Addendum #1

**Peoples Regional Opportunity Program
Phase III Scattered Site Affordable Housing
Anderson & Cumberland Streets, Portland, Maine 04101
North Street, Westbrook, Maine 04101**

January 28, 2005

Phase III Affordable Housing

SKC-1

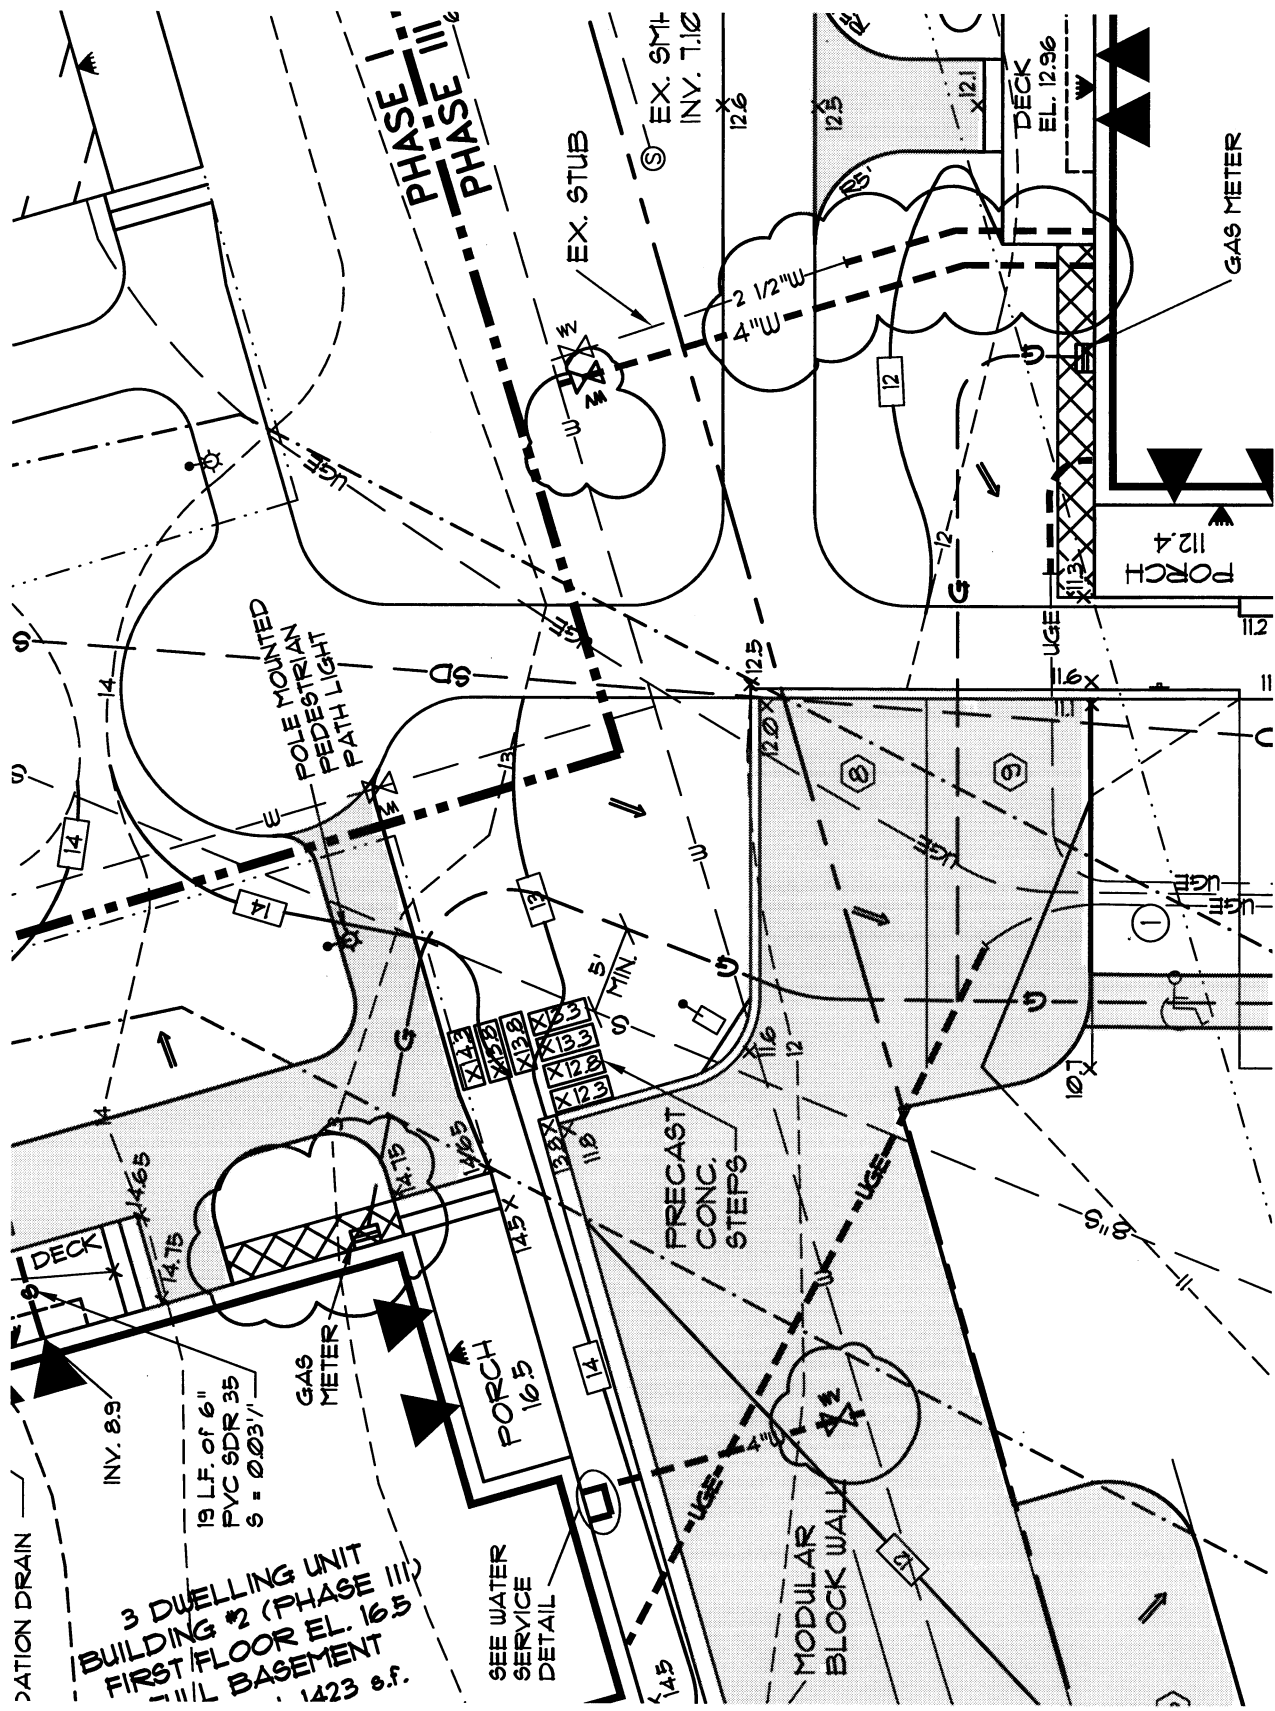
<u>Item</u>	<u>Sheet</u>	<u>Detail</u>	<u>Description</u>
1-30	M1.1	17 North	Heating plan
1-31	M1.2	17 North	Plumbing plan
1-32	M1.1	23 North	Heating plan
1-33	M1.2	23 North	Plumbing plan
1-34	SkC-1	-	Replace legend on sheet C1 with attached SkC-1
1-35	SkC-2	-	Add drip strip on the south side of Anderson Building 2 under the gas meter 15’ +/-.

SKC-3

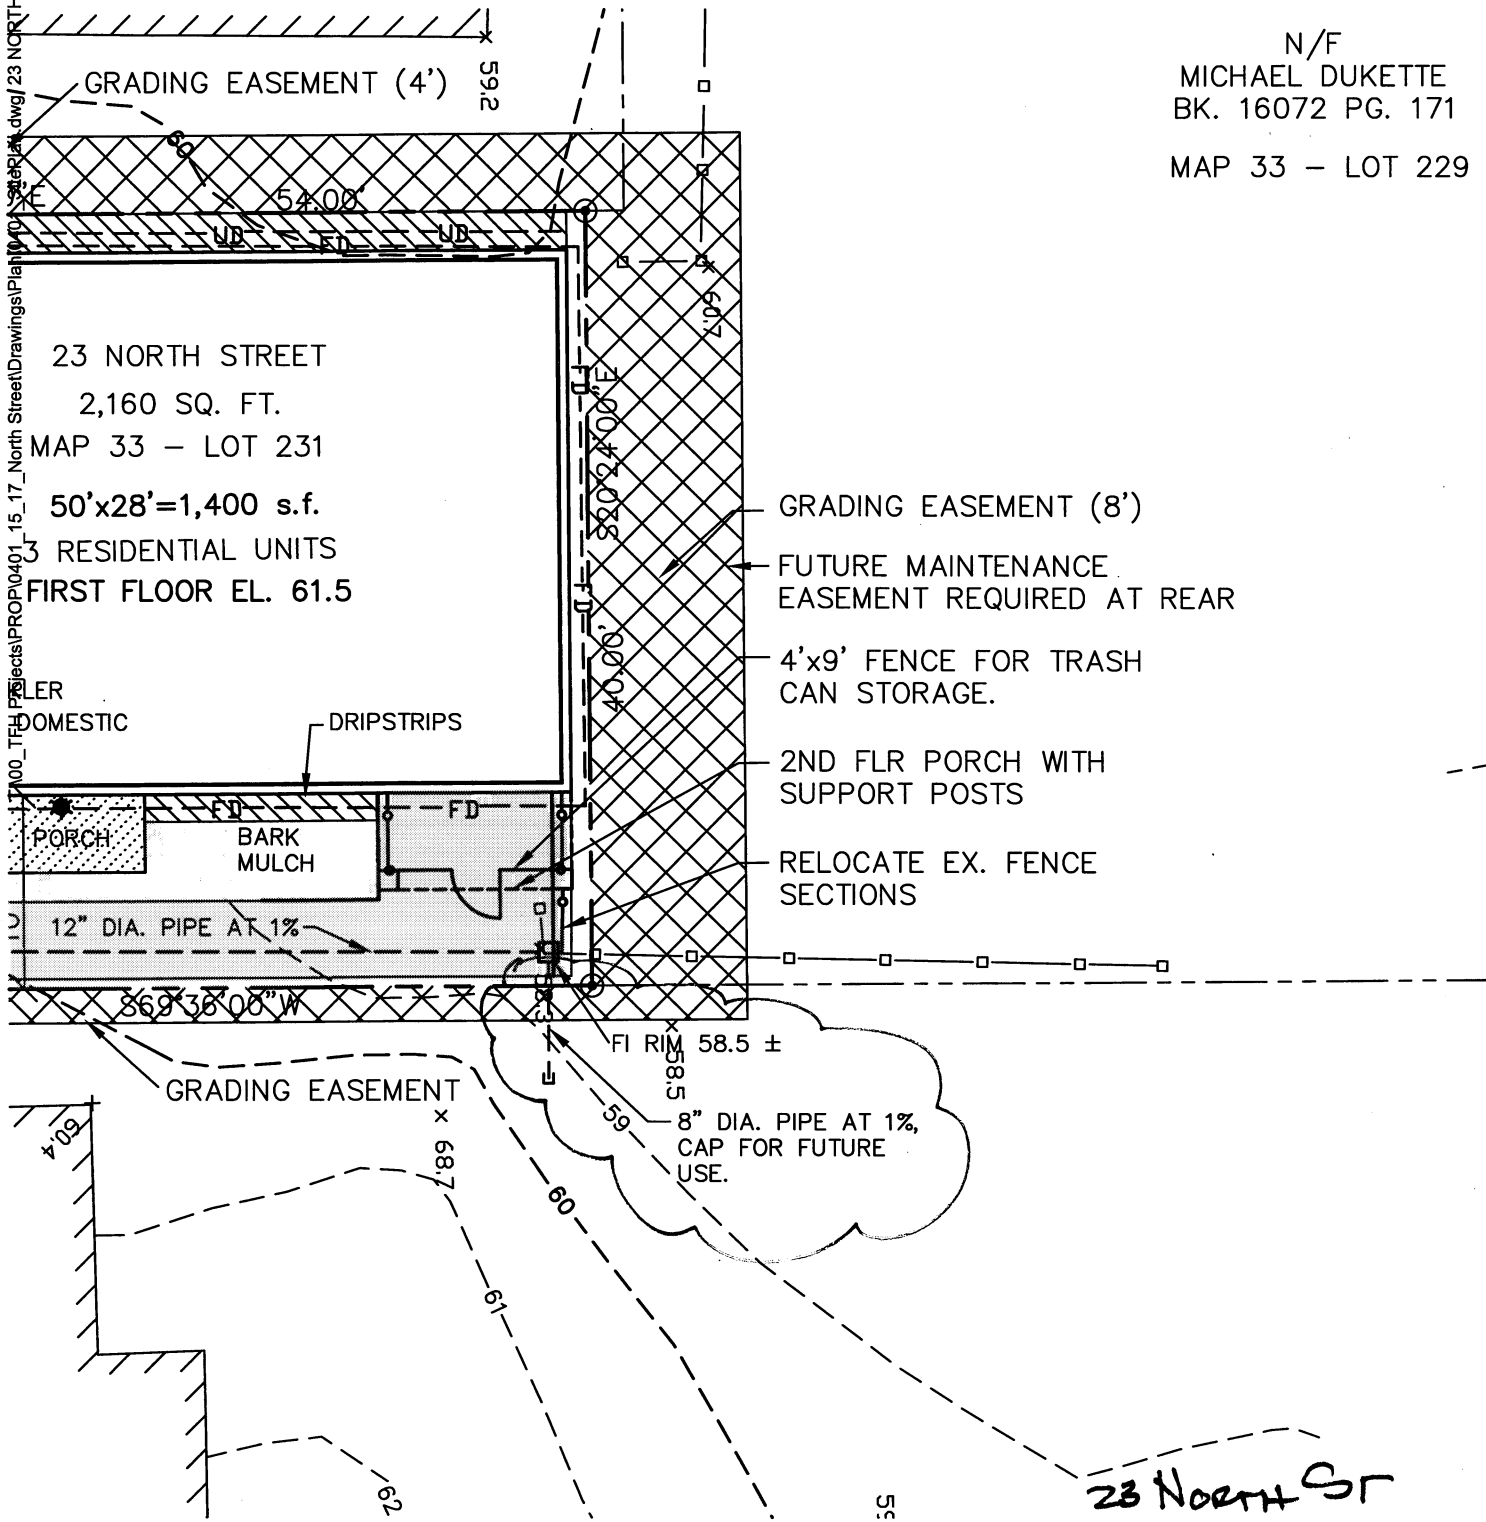
- 1-16 Section 02200, Add table on SkC-3 to the end of Specification for clarification of excavation and sub grade preparation.

23 North St
PARTIAL C.I.O
1/28/05
SKC-4

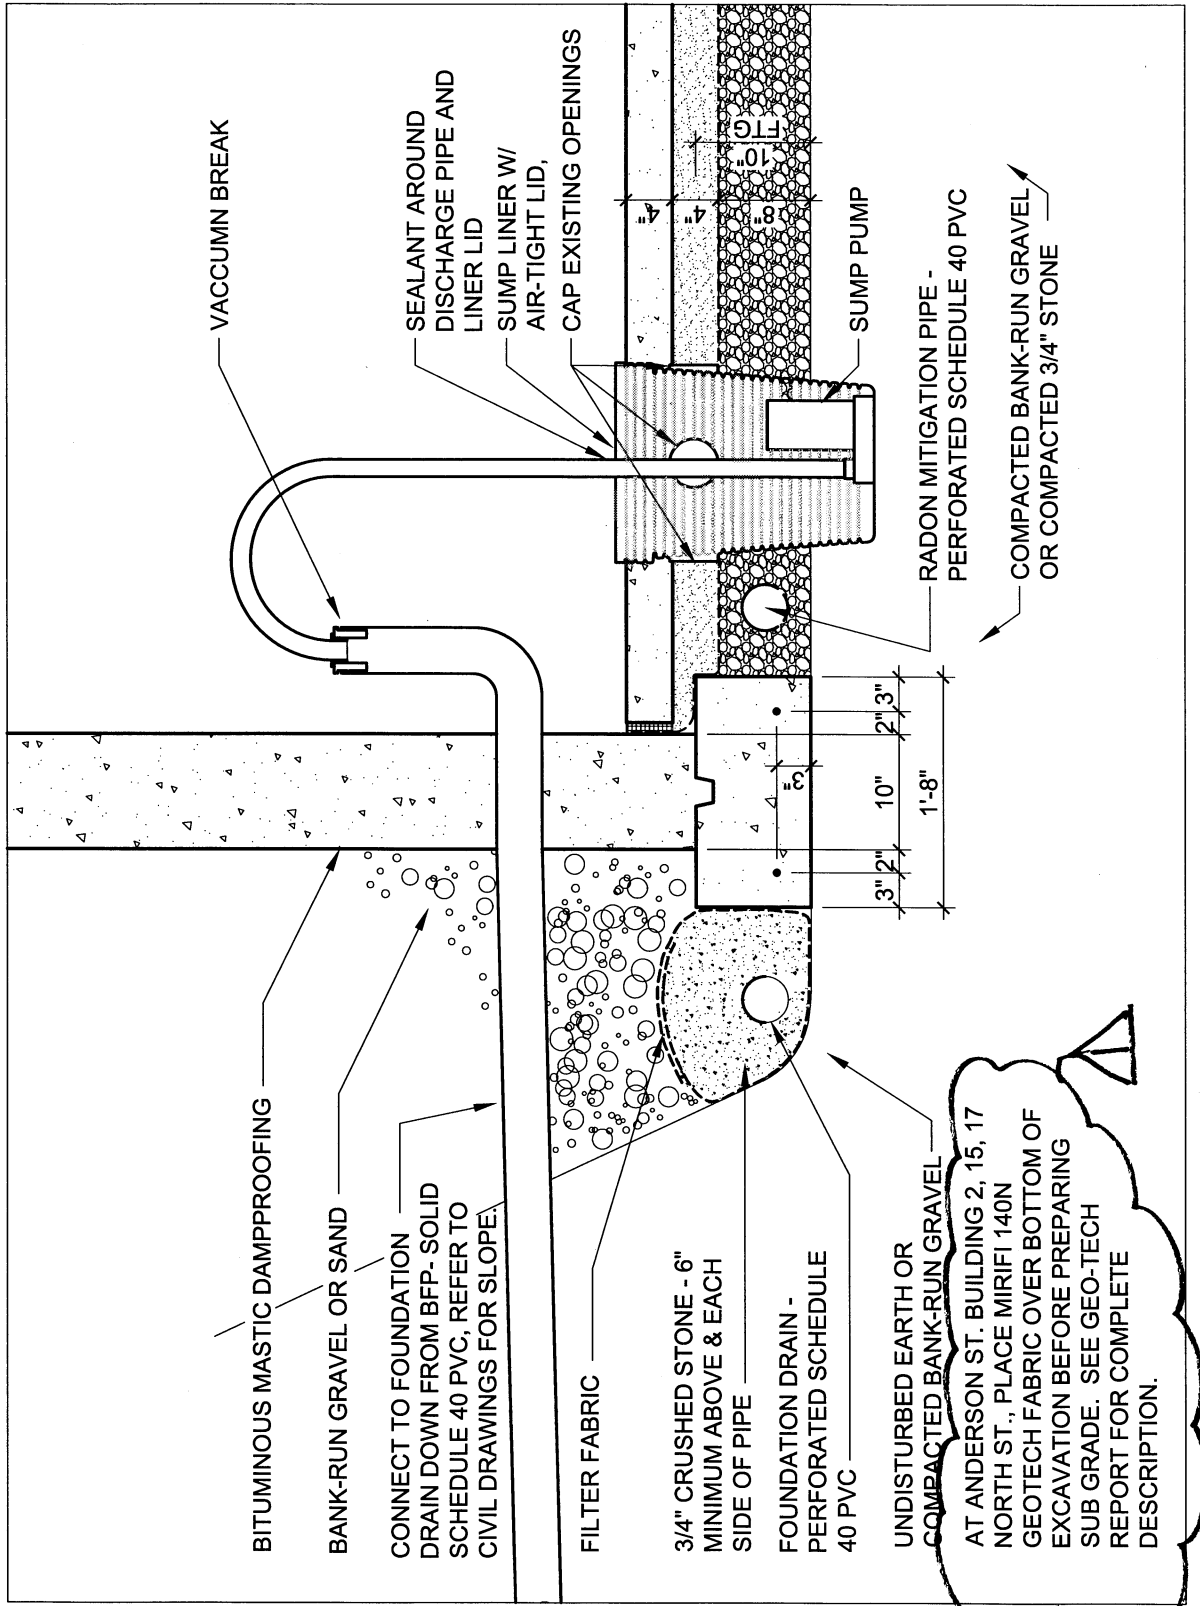
<u>Item</u>	<u>Sheet</u>	<u>Detail</u>	<u>Description</u>
1-17	C1	Anderson	The phase line shown on Sheet C3 is for the owners use. Work is required on both sides of the link to blend in the grading and utilities.
1-18	C1	Anderson	For building #3 extend the 2 ½ “ water line to the building and use it for domestic service. Delete the split of the 4” water at the building.
1-19	C1	Anderson	For buildings 2 and 3, add tapping sleeve and gate valve for the 4” taps to the existing water main.
1-20	C1	Anderson	Replace the entire sidewalk along Anderson St with brick. Finish per City Standards.
1-21	C1	Cumberland	Replace the entire sidewalk towards Cumberland Avenue with brick sidewalk. The entire sidewalk will be disturbed when the shoring system is installed. Finish per City Standards.
1-22	C1	Cumberland	Delete 4 floor drains and connection to storm drain system.
1-23	C1.0	23 North	Add 8’ of 8” pipe, stub and cap for future use. See SkC-4.

4 SUMP
A4-0 3/4" = 1'-0"

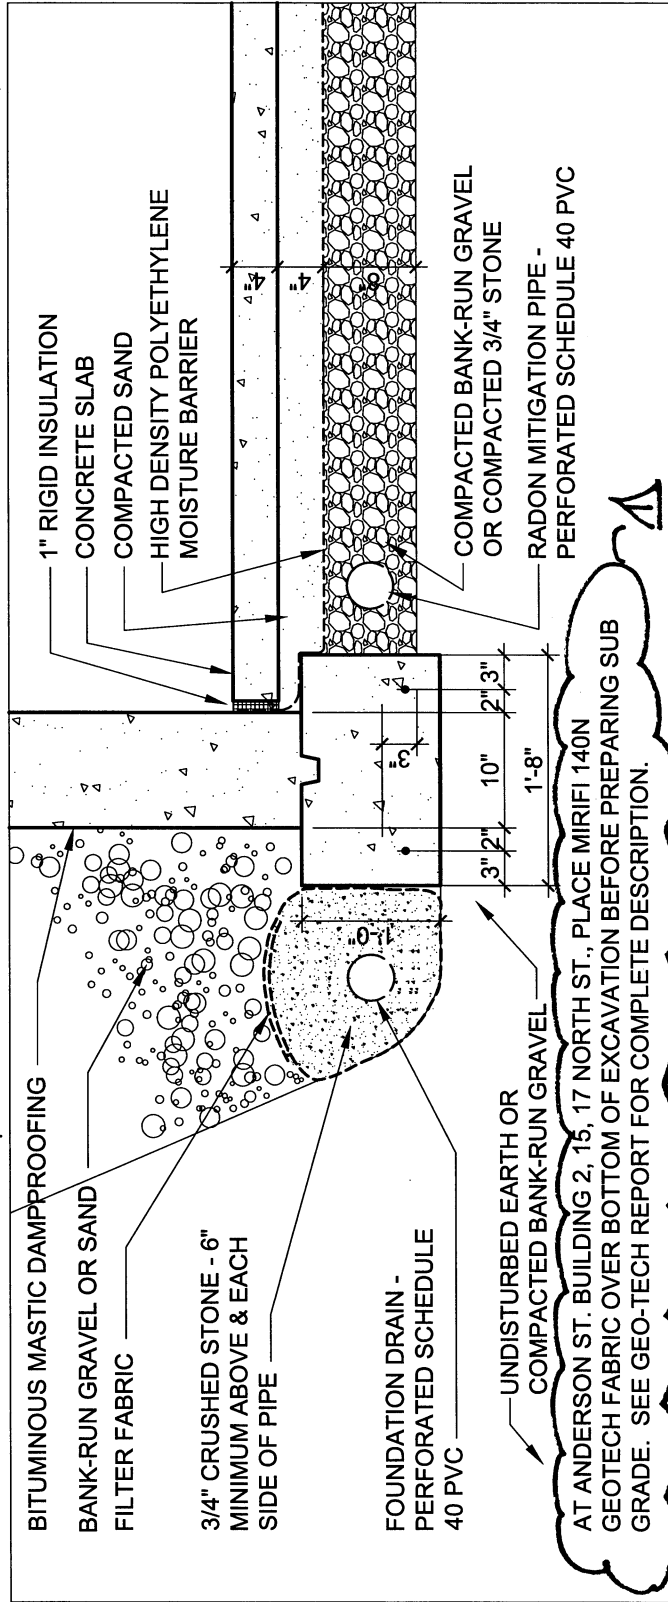
1-24	A1.0, A1.1, A1.2,		All sites Add note 11 for underlay @ linoleum floors.
1-25	A.0, A1.1, A1.2,		All sites Add note 11 for underlay @ linoleum floors.
1-26	A2.3	3, 4	All sites Add soffits above upper cabinets for vent duct.
1-27	A4.0	Anderson 3,4	Add geotech fabric per Geotech reports
1-28	A4.0	15, 17 North St. 3,4	Add geotech fabric per Geotech reports
1-29	A1.0, A1.1, A1.2,		All sites General Finish notes - Add note 11 for underlay @ linoleum floors.
